Licence Number	L6637/1995/15
Licence Holder	Electricity Generation and Retail Corporation
ACN	58 673 830 106
File Number:	DER2015/000109
Premises	Collie 'A' Power Station Boys Home Road PALMER WA 6225 Being Part of Lot 3001 on Plan 51101
Date of Amendment	26 October 2017

Amendment

On 11 April 2017, the Licence Holder submitted an application to amend Licence L6637/1995/15 for the Collie 'A' Power Station. Appendix 1 contains a list of the documents that form the Application.

Figure 4: Upstream construction method for Cell 2B with location of underdrainage pipes indicated

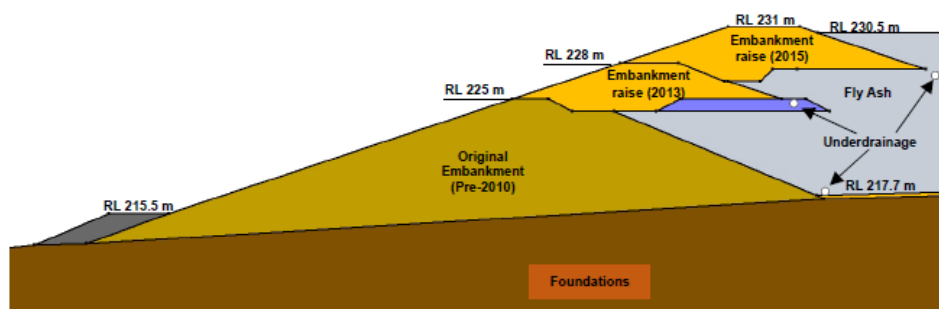
The 3 m raise will be undertaken in a single lift using the upstream method of construction, to a final height of 231 m AHD. The discharge of slurry will occur at the perimeter embankment to create a solid beach foundation along the outer edge of the dam. Underdrainage will be placed at the upstream toe to control the phreatic surface within the embankment and to reduce pore pressure within the deposition mass.

The embankment raise contains a seepage berm at the base of the FAD, internal causeways, decant and underdrainage lines, and pumping infrastructure. The areas in Figure 4 below show the raise areas relative to the underdrainage lines at the upstream toe of the embankments. The grey structure identified at RL215.5 m shows the relative position of the external seepage berm.

The embankment design does not contain a berm at the rise level and incorporates a continuous slope of approximately 19%.

Figure 5: Phreatic surface within Cell 2B without a seepage berm or operational underdrainage system

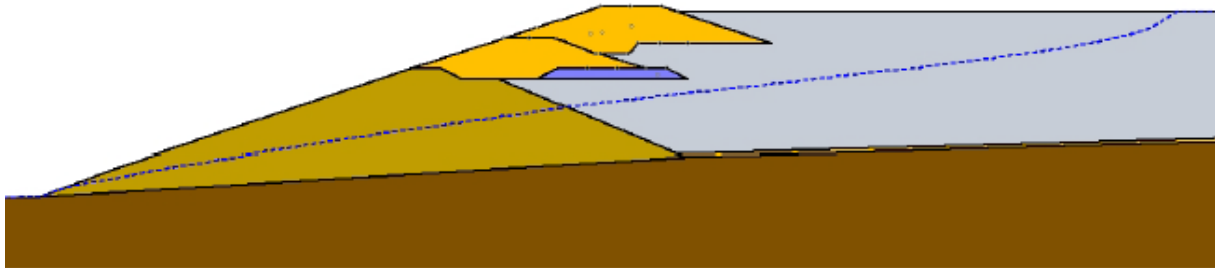
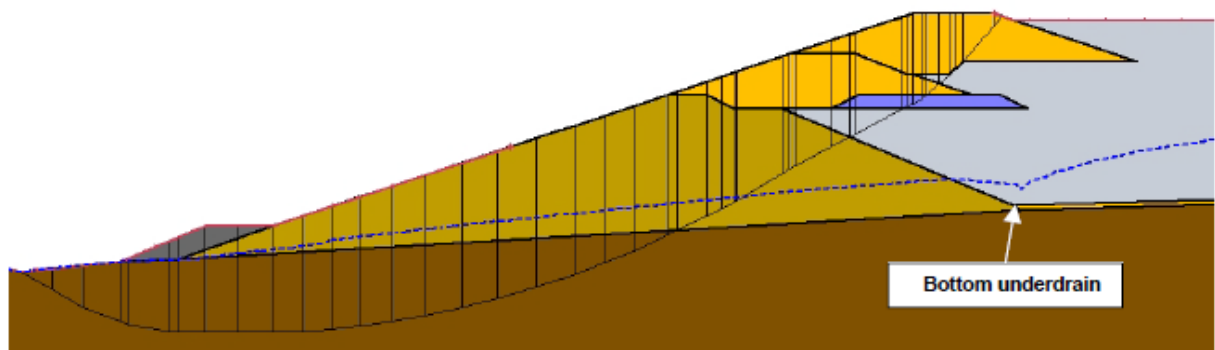
Figure 5 and Figure 6 below show the expected phreatic surface (dotted blue line) within Cell 2B with and without the seepage berm and underdrainage system. The construction of a seepage berm at the base of Cell 2A and Cell 2B will reduce upward seepage and piping through the embankment walls. Without these seepage management options, the stability of the embankment may be compromised.

The discharge of slurry will occur at the perimeter embankment to create a solid beach along the external edge of Cell 2B with the decant pond located approximately 100 m from the outer embankment of the dam. The Delegated Officer considers that multi-spigot discharge will assist in managing the size and extent of the decant pond within the deposition mass, especially during wetter periods when a change to the beaching area is required.

Figure 7: Map of piezometer locations

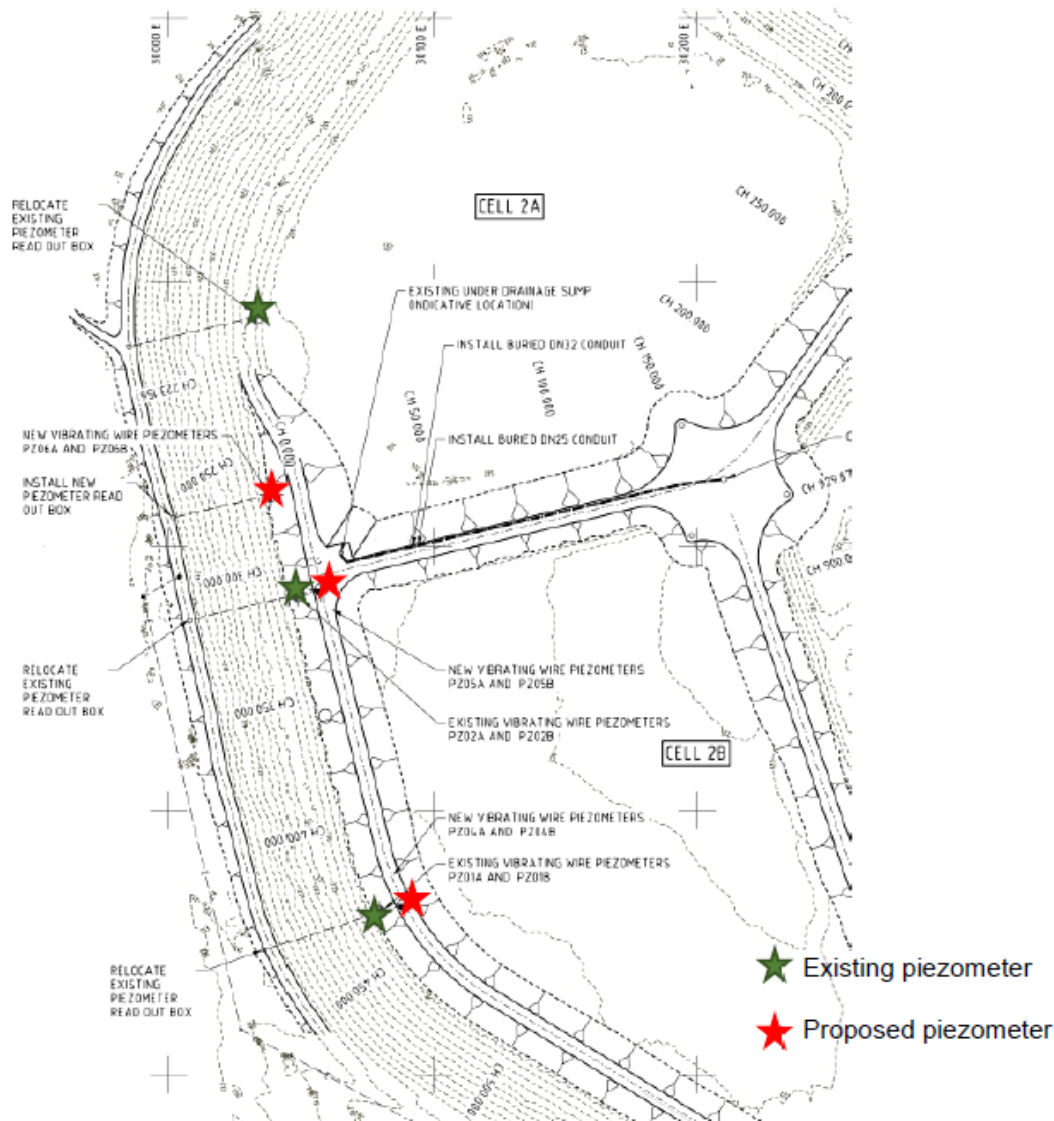
During construction, six new vibrating wire piezometers (VWP) will be installed at three locations in the embankment walls of Cell 2B to monitor pore pressure within the embankments (see Figure 7 below). VWPs exist at three locations within the existing embankment walls to measure the phreatic surface within the flyash to indicate if seepage is present.
